RESOLUTION MEPC.261(68)
(adopted on 15 May 2015)
AMENDMENTS TO THE 2014 GUIDELINES ON SURVEY AND CERTIFICATION
OF THE ENERGY EFFICIENCY DESIGN INDEX (EEDI)
(RESOLUTION MEPC.254(67))

ANNEX 6

**AMENDMENTS TO THE 2014 GUIDELINES ON SURVEY AND CERTIFICATION
OF THE ENERGY EFFICIENCY DESIGN INDEX (EEDI)
(RESOLUTION MEPC.254(67))**

Figure 2: An example of scheme of conversion from trial condition to EEDI condition at EEDI power

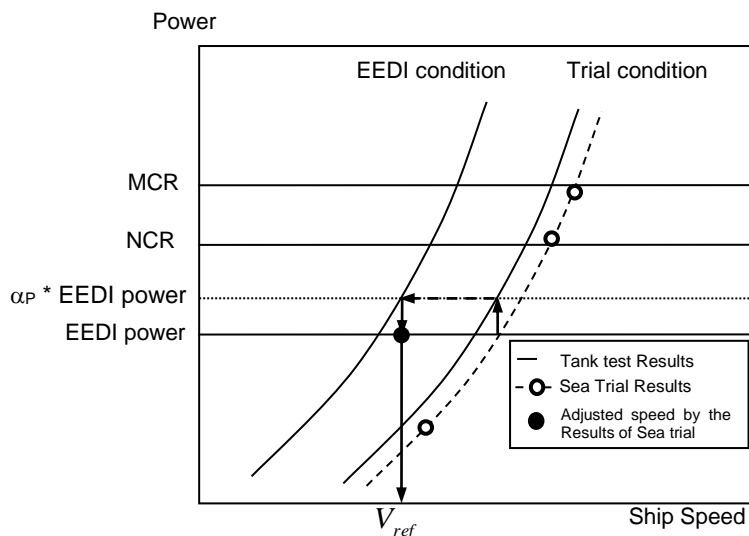
4.3.9 The submitter should compare the power curves obtained as a result of the sea trial and the estimated power curves at the design stage. In case differences are observed, the attained EEDI should be recalculated, as necessary, in accordance with the following:

- .2 for ships for which sea trial cannot be conducted under the condition as specified in paragraph 2.2 of the EEDI Calculation Guidelines: if the measured ship speed at the power of the main engine as specified in paragraph 2.5 of the EEDI Calculation Guidelines at the sea trial conditions is different from the expected ship speed on the power curve at the corresponding condition, the shipbuilder should recalculate the attained EEDI by adjusting ship speed under the condition as specified in paragraph 2.2 of the EEDI Calculation Guidelines by an appropriate correction method that is agreed by the verifier.

An example of scheme of conversion from trial condition to EEDI condition at EEDI power is given as follows:

V_{ref} is obtained from the results of the sea trials at trial condition using the speed-power curves predicted by the tank tests. The tank tests shall be carried out at both draughts: trial condition corresponding to that of the S/P trials and EEDI condition. For trial conditions the power ratio α_P between model test prediction and sea trial result is calculated for constant ship speed. Ship speed from model test prediction for EEDI condition at EEDI power multiplied with α_P is V_{ref} .

Figure 2 shows an example of scheme of the conversion to derive the resulting ship speed at EEDI condition (V_{ref}) at EEDI power.

$$\alpha_P = \frac{P_{Trial,P}}{P_{Trial,S}}$$

where:

$P_{Trial,P}$: power at trial condition predicted by the tank tests

$P_{Trial,S}$: power at trial condition obtained by the S/P trials

α_P : power ratio
